Application No.
21/00092/CON

**Land At Tilehurst Lane Tilehurst Lane Binfield
Bracknell Berkshire**

Details pursuant to conditions 25 (External Lighting) & 26 (Lighting Design for Biodiversity) of planning permission 18/00758/FUL (APP/R0335/W/19/3231875).

OFFICER REPORT

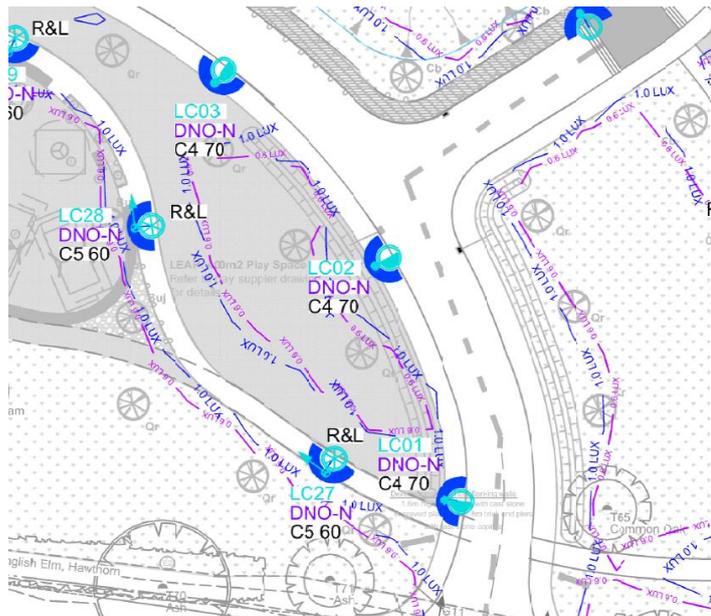
- 9.7 The submitted information confirms the very limited light spill that will result from each luminaire, each of which will be fitted with a rear shield. An extract from the Lighting Layout plan below, indicates a contour where the level of light spill for each luminaire is 1 lux:

- 9.8 As indicated in the Highway Lighting Engineer's comments, 2 lux of light spill at a residential window would be considered obtrusive. However, the submitted information demonstrates that very limited light spill will be emitted from individual lights, and the 2 lux level would not result in proximity to any residential property. As a result, the proposed lighting scheme is considered to have an acceptable impact upon the residential amenities of dwellings both within the development and beyond.
